PREVOST

Warranty Bulletin

96-11A

Subject: RE-ENFORCEMENT SCREWS ON PASSENGER-SEAT-ARMREST-

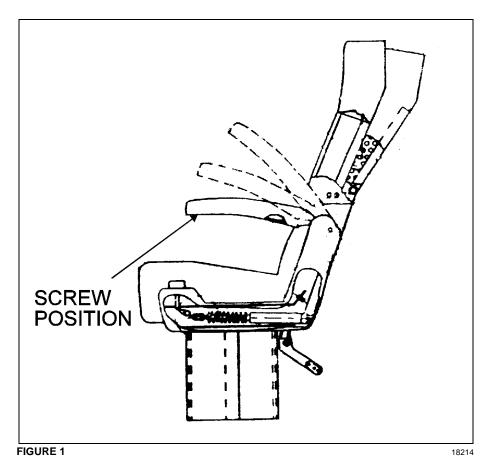
Both aisle-side and central armrests on all passenger seats are to be reinforced as follows:

- 1. Lift the armrest up.
- 2. For each armrest:
 - Locate hole underneath armrest cover (Fig. 1);
 - Align a 1/8 inch drill in the hole and make a hole in the armrest;
 - · Install a washer and a screw.

Screw #500686 replaced by screw #500333.
